Michael Collins Architect LLP

158 Cambridge Road

Job No. 242 North Elevation
as Proposed

Stage: Stage 3
Status: NMA

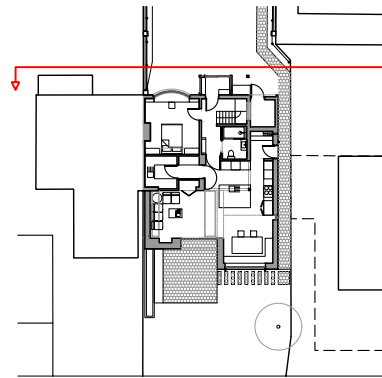
| a. Proposed Glazed Timber Frame Porch | i. Proposed Slit Window, Aluminium Framed - kitchen slit window to be removed | s. Tone with Existing Roof |
| f. Proposed 47mm Siberian Larch Cladding with weathered stain also proposed at first floor level in place of aluminium standing seam cladding and within set-in bike store wall in place of render | n. Proposed Bauder Wildflower Green Roof System | w. Proposed Espalier Wire and Post Climber Support |
| g. Replacement Aluminium Window (Jet Black) with 2 no. horizontal astragals | o. Existing Pitched Brown Tiled Roof Re-Tiled, with Existing and New Tiles to Match | x. Neighbouring Property 160 Cambridge Road indicative based on Planning Drawings |
